**Comment (Two comments marked ISO\_01 and ISO\_02, clause 145.4.1 page 217 line 39)**

## Annex A – PSE – PD configurations for specifying isolation.

Figure 1: Dual-signature, single load PD.

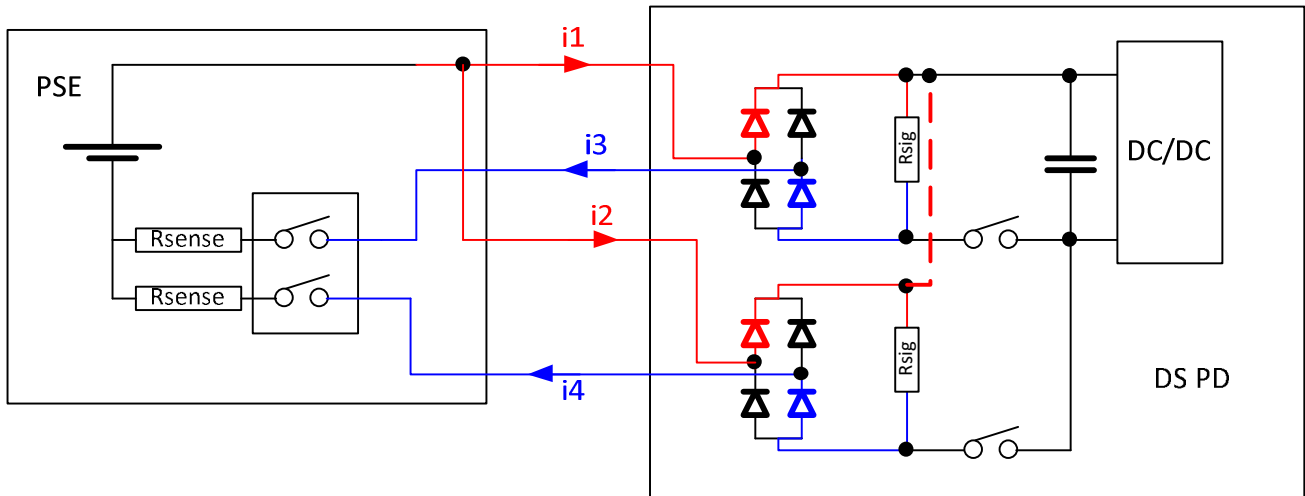
- Switching on the negative is mandatory
- Measuring current on the negative when switching on the negative is the only practical choice since measuring on the positive will result with pairs currents that are not correlated to the negative pairs currents due to unbalance.
- As a result, it is guaranteed only in the negative pairs, that PSE will support PD successfully when measuring the pair current for connection check, detection and classification circuits in dual-signature PDs.
- In addition, the positive side is tied together at the PSE side which effectively, tied the positive pairs at the PD side as well.

Figure 2: Dual-signature, dual load PD.

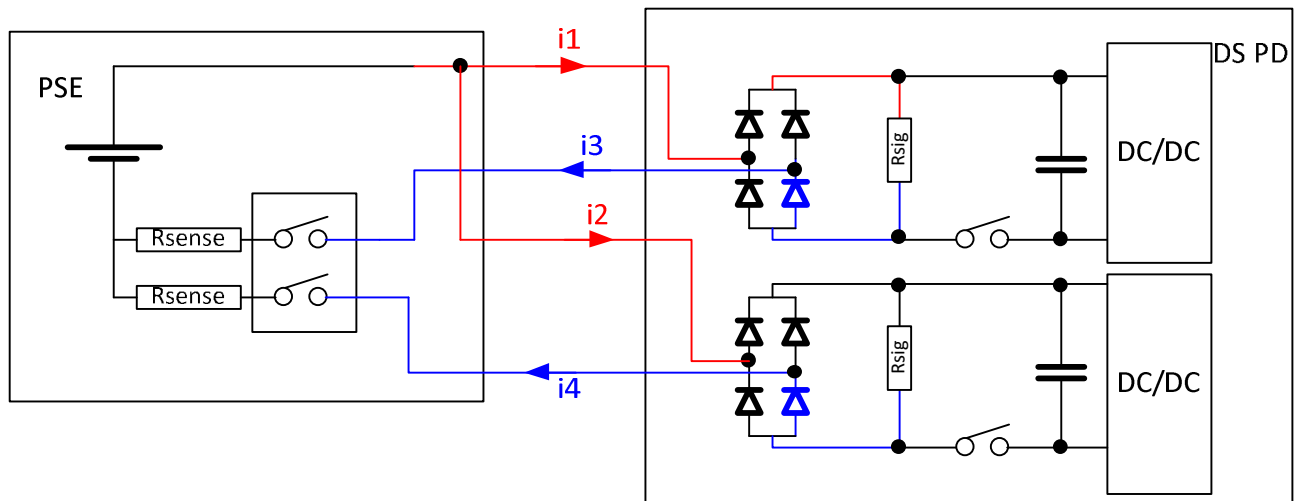
By definition, the positive pairs and negative pairs are isolated in the PD primary side (secondary may have common GND and typically this is the case). However, since as in the previous case the PSE is required to support switching on the negative pairs, PD is not guaranteed to be supported on the positive pairs making the isolation requirements on the PD positive pairs with no value.
